UNITED STATES ENVIRONMENTAL PROTECTION AGENCY
REGION IX – PACIFIC SOUTHWEST REGION
75 Hawthorne Street
San Francisco, CA 94105-3901

The purpose of this letter is to transmit to you EPA's Clean Water Act (CWA) inspection report on PMC Direct Pack Inc. facility and to notify you of significant compliance concerns with the Clean Water Act. As you are aware, on December 10, 2015, EPA inspected PMC Direct Pack Inc. to determine if the facility is in compliance with the CWA and the requirements of the State of California's *NPDES General Permit for Discharges of Storm Water Associated with Industrial Activities* (Industrial General Permit or IGP, No. CAS000001; Water Quality Order No. 2014-0057-DWQ).

Region 9 Enforcement Division
75 Hawthorne Street
San Francisco, CA 94105
INSPECTION REPORT

Inspection Date:	12/10/2015		
Time:	Entry: 8:25 a.m.	Exit: 11:30 a.m.	
Media:	Water		
Regulatory Program:	CWA NPDES/Industrial Storm Water		
Company Name:	Direct Pack, Inc.		
Facility or Site Name:	PMC Direct Pack, Inc.		
Facility/Site Physical Location:	12243 Branford Street		
(city, state, zip code)	Sun Valley, CA 91352		
Geographic Coordinates:	34°15'4.54"N, 118°24'2.09"W		
Facility/Site Contact

*Image A: Google Earth image of Facility
12243 Branford Street, Sun Valley, CA 91352*

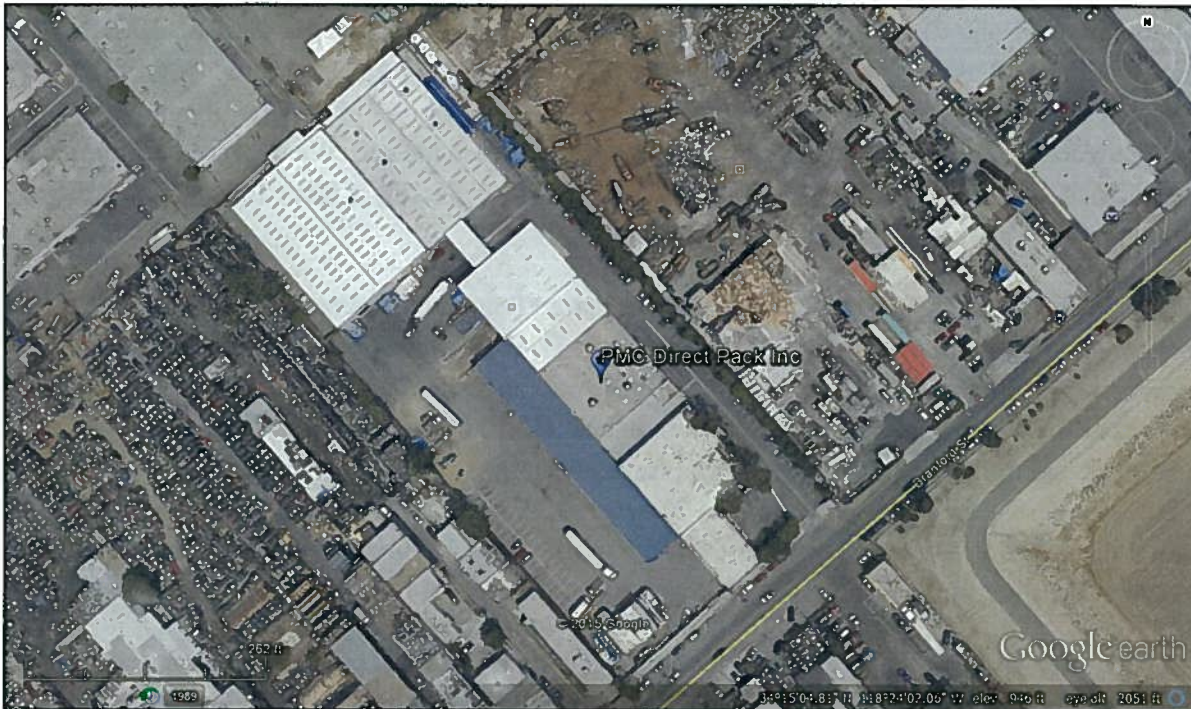
The Direct Pack, Inc. – PMC Direct Pack, Inc. Facility is an approximately 4-acre site with two entrances onto Branford Street, located at the southern area of the Facility. The Facility consists of an administrative building, parking areas, a large production building, a warehouse, loading and unloading dock, and multiple covered storage areas. Refer to the *Google Earth* imagery below (Image A).

Photograph 1. View, facing south, of the South Discharge Point located at the southern area of the Facility. Note the pooling water in the discharge point.

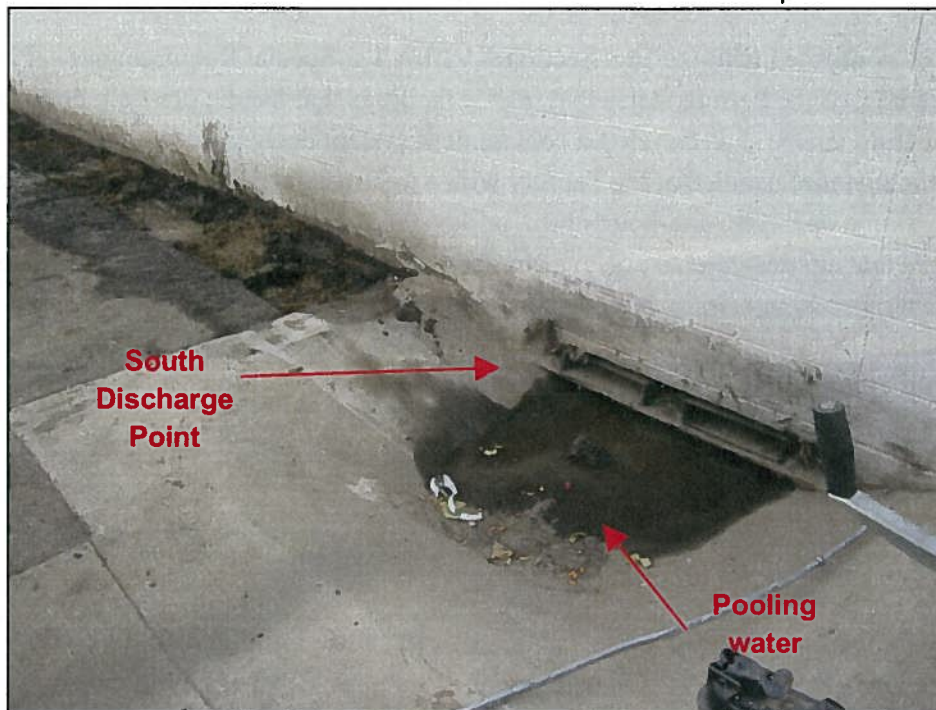
Vacuum system(s) available?	Yes	
Containment system or alternative for plastics materials < 1mm in size	No	We observed that the Discharger had installed a mesh screen in the sump at the northeastern perimeter of the Facility (Photograph 20). We also observed that the Discharger had not implemented a containment system designed to trap the plastic particles at the Southeast Discharge Point or the South Discharge Point (Photographs 1 and 2).

15. We observed that the Discharger had not fully implemented a containment system at the discharge points to trap plastic material and keep it from discharging offsite. Specifically, we observed that the Discharger had not deployed containment BMPs at the South Discharge Point or the Southeast Discharge Point at the Facility. Mr. Mendoza explained that the storm water and potential plastic pieces would likely settle at the South Discharge Point and thus would not discharge from the Facility (Photograph 1). However, this could

Photograph 5. View, facing west, of uncontained Supersacks of plastic flakes. Note the plastic flakes accumulated on the impervious surface beneath the Supersacks.

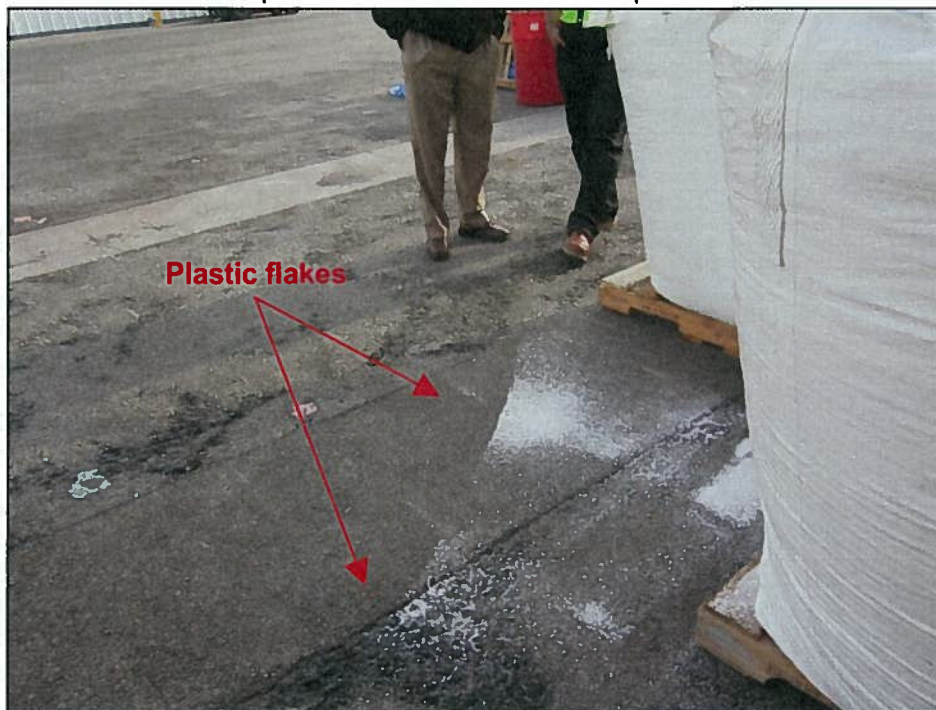
Yes/No	Comments
Good Housekeeping	No	We observed exposed plastic flakes that were uncovered and uncontained on the impervious surface of the Facility that could be mobilized during a storm event (Photographs 3 through 7).
	No	We observed oil staining on the impervious surface at

2. We observed that good housekeeping practices had not been implemented at the Facility or established in the SWPPP to properly handle tracked materials per the Permit. Specifically, we observed tracked plastic flakes near the western and central-western perimeter of the Facility, within a storm water cross path (Photographs 3 through 7). We observed the potential for the plastic flakes to be mobilized via the storm water cross path to the South Discharge Point. Section X.H.1.a.v, Good Housekeeping Minimum BMPs, of the Permit, states that the Discharger shall cover all stored industrial materials that can be readily mobilized by contact with storm water. Due to the conditions we observed onsite, the Facility had not implemented practices at the Facility or included these practices in the SWPPP per the good housekeeping and plastic containment requirements in Sections X.H.1.a.v of the Permit.

Photograph 9. View, facing northwest, of oil staining observed on the impervious surface at the southeastern area of the Facility.

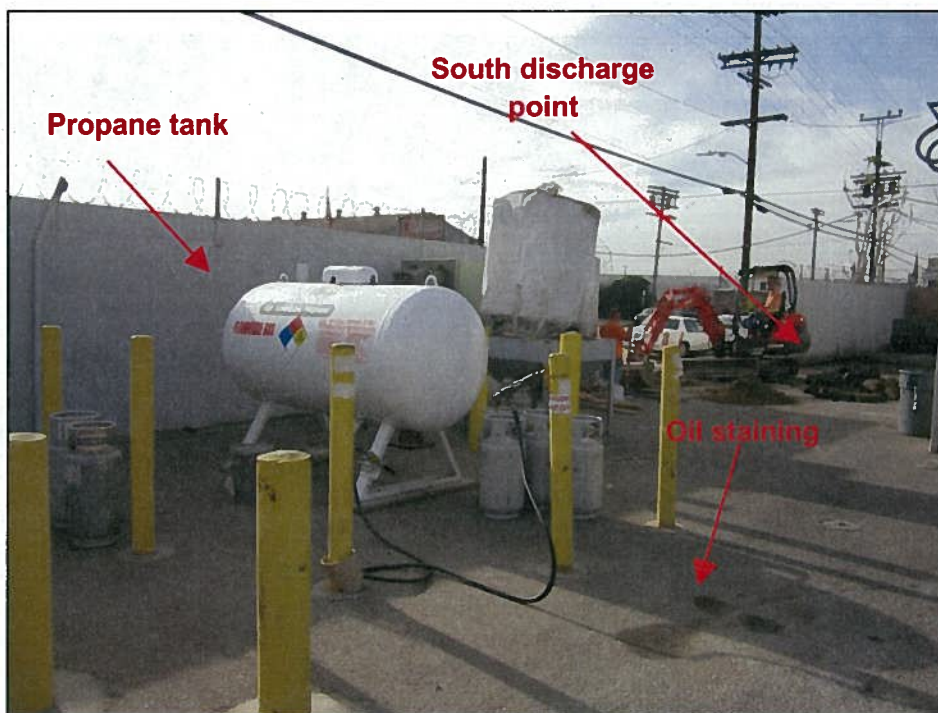
3. We observed that procedures for prompt preventative maintenance activities had not been implemented at the Facility per the Permit. Specifically, we observed oil staining on the impervious surface at the southeastern and southern areas of the Facility (Photographs 9 and 10). Section X.H.1.b.iv, Preventive Maintenance Minimum BMPs, of the Permit, states that the Discharger shall establish procedures for prompt maintenance and repair of equipment, and maintenance of systems when conditions exist that may result in the development of spills or leaks. Due to the oil staining observed at the Facility, it appeared that the Discharger had not implemented procedures for prompt maintenance and repair

4. We observed that procedures for spill and leak prevention and response had not been implemented at the Facility per the requirements in the Permit. Specifically, we observed two 55-gallon drums of emulsion chemicals stored at the northwestern perimeter of the Facility without overhead coverage or containment (Photograph 11). We also observed multiple 5-gallon buckets of various chemicals including a protective film coating at the southern corner of the Facility without containment or overhead coverage (Photographs 12 and 13). Section X.H.1.c.i, Spill and Leak Prevention and Response Minimum BMPs, of the Permit, states that the Discharger shall establish procedures and/or controls to minimize spills and leaks. SWPPP Section 5.B states for material handling and storage, refer to Table 4-1. Table 4-1 is not identified in the SWPPP. From the conditions we observed onsite, the Discharger was not properly implementing spill and leak prevention and response procedures as required by Section X.H.1.c.i of the Permit.

Photograph 12. View, facing south, of six uncovered and uncontained 5-gallon buckets of various chemicals, including a protective film chemical, stored at the southern corner of the Facility.

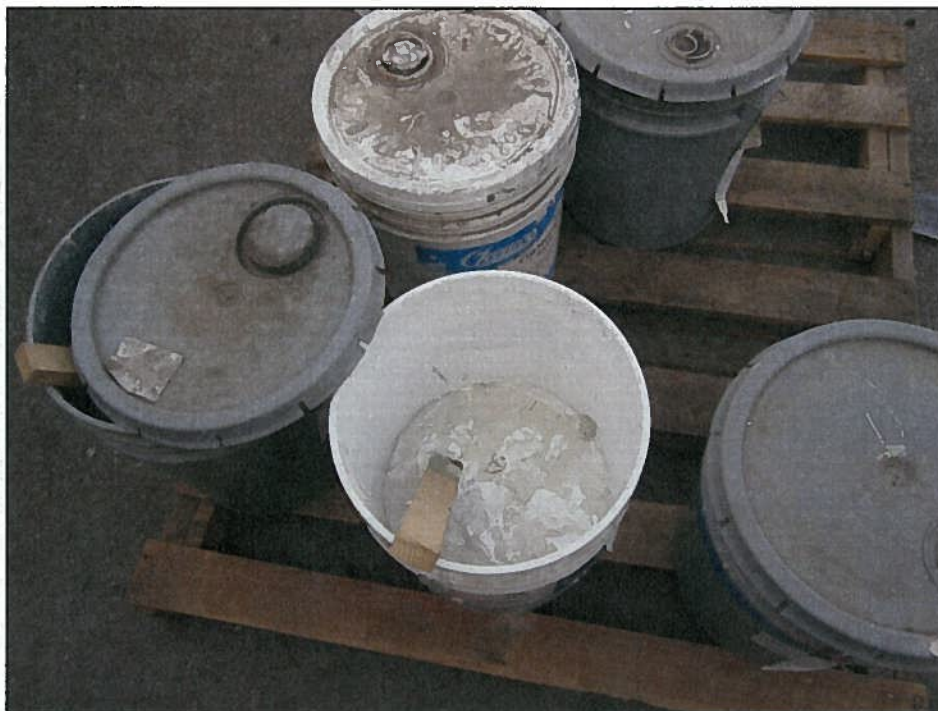
5. We observed that all materials handling and waste management BMPs had not been implemented at the Facility or addressed in the SWPPP per the Permit. Specifically, we observed two uncovered and uncontained garbage bins located in the southcentral area of the Facility (Photograph 8). Section X.H.1.d.iii, Material Handling and Waste Management Minimum BMPs, of the Permit, states that the Discharger shall cover industrial waste disposal containers and industrial material storage containers that contain industrial materials when not in use. SWPPP Section 5.G states that the trash bin is required to be in good conditions, leak proof and covered prior to and during expected rain events. We observed that the Discharger was not properly implementing the materials handling and waste management BMPs and that the SWPPP did not properly address these BMPs as required per Section X.H.1.d.iii of the Permit.

Photograph 14. View, facing south, of the partially uncovered, inactive equipment stored along the southwestern perimeter of the Facility, upgradient of the South Discharge Point.

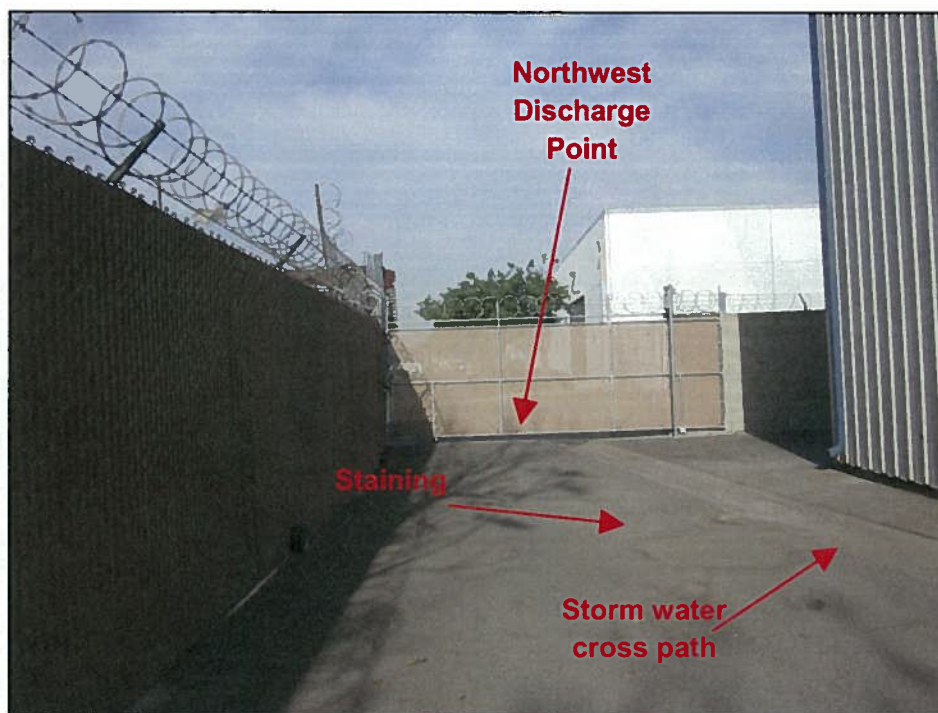
- d. *Structural storm water controls.* We observed a storm water cross path that ran along the western perimeter of the Facility and conveyed storm water either to the Northwest Discharge Point or the South Discharge Point (Photographs 3 and 4, 7, 15, and 16). The storm water cross path was not identified on the Facility site map.

- e. *Location of directly exposed materials.* We observed that the Discharger identified storage areas on the Facility site map but did not specifically identify these areas as location where directly exposed materials were stored. We observed several locations with directly exposed materials during the inspection. Specifically, we observed uncontained plastic flakes in the storm water cross path (Photographs 3 through 7), partially uncovered equipment (Photograph 16), and uncontained plastic pellets at the northern corner of the Facility (Photographs 17, 18, and 28).

Photograph 19. View, facing northwest, of the area used for floor mat cleaning near the northeastern perimeter of the Facility. This area was not identified as a cleaning area on the Facility site map. Note the wash water collecting in the sump.

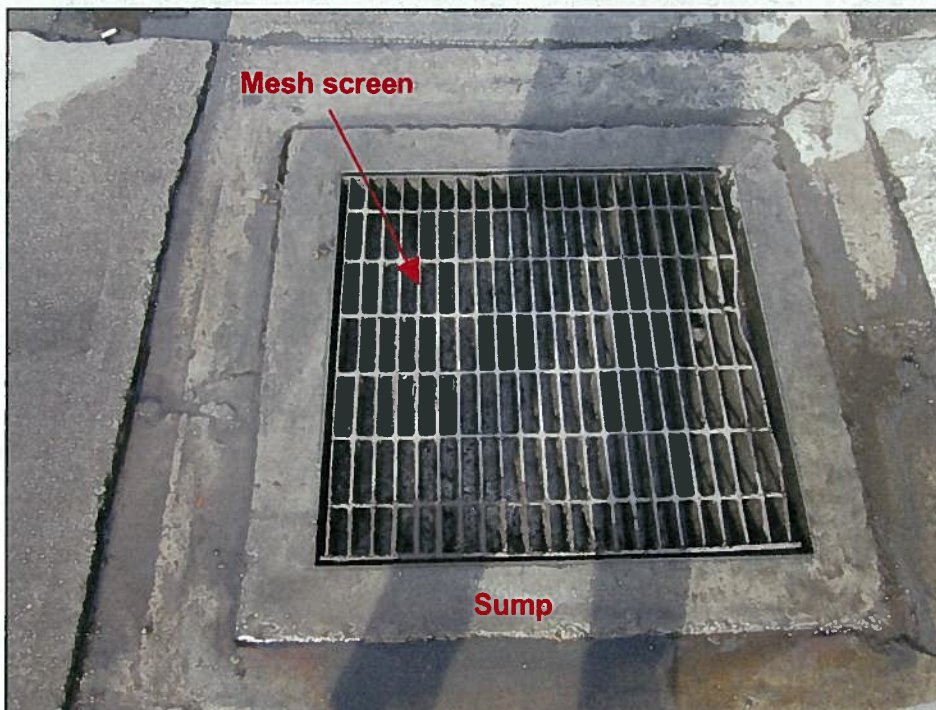
We observed floor mat cleaning occurring at the northeastern perimeter of the Facility, to the east of the production building. Soapy wash water was being generated from this process and was flowing toward and collecting within a nearby sump (Photographs 19 and 20). We observed an oily sheen on the surface of the wash water within the sump (Photograph 21). Mr. Mendoza explained that the wash water collects in the sump and that a float activated pump within the sump conveys the water via a pipe to the Facility's Southeast Discharge Point (Photograph 22). Mr. Mendoza explained that the sump was intended to be used to transport storm water to the Southeast Discharge Point. We then proceeded to the Southeast Discharge Point and observed the wash water flowing from the sump to the Southeast Discharge Point, through an unknown conveyance pipe and onto Branford Street (Photographs 23 through 27). We observed the wash water (NSWD) from the Facility accumulating in the curb and gutter line and flowing down Branford Street. Section I.C.28, Discharge Prohibitions, of the Permit, states that prohibited NSWDs are referred to as unauthorized NSWDs in the general permit. Unauthorized NSWDs may contribute significant pollutant loads to receiving waters. Measures to control sources of unauthorized NSWDs such as spills, leakage, and dumping, must be addressed through the implementation of BMPs. The Discharger had not deployed effective BMPs onsite to mitigate the potential for an unauthorized NSWD of wash water to occur at the Facility per Section I.C.28 of the Permit.

- i. *Cleaning and material reuse areas.* We observed mat cleaning occurring at the northeastern perimeter of the Facility, to the east of the production building. We observed soapy water being generated from the cleaning activity and collecting within a sump (Photographs 19 through 22). The Discharger did not identify this area as a cleaning area on the Facility site map.

Photograph 22. View, facing southeast, of the pipe that conveys water from the sump at the east-central perimeter of the Facility to the Southeast Discharge Point depicted in Photographs 2 and 23.

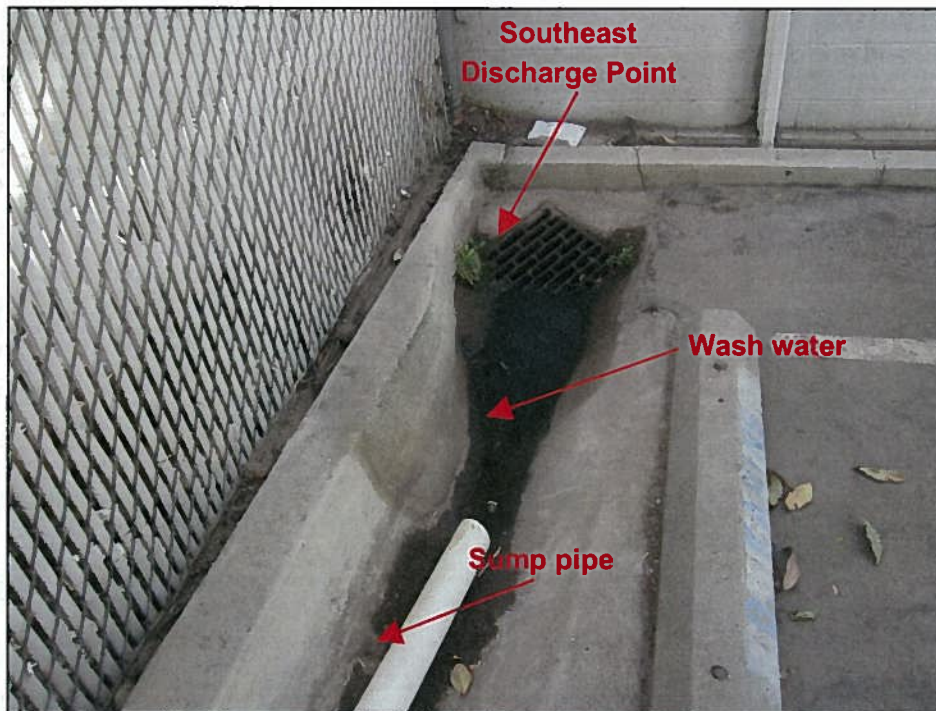
1. The Discharger had not implemented effective BMPs in an effort to prohibit unauthorized NSWDS from occurring at the Facility per the Permit. Specifically, we observed an unauthorized NSWDS actively occurring from the Facility at the time of the inspection.
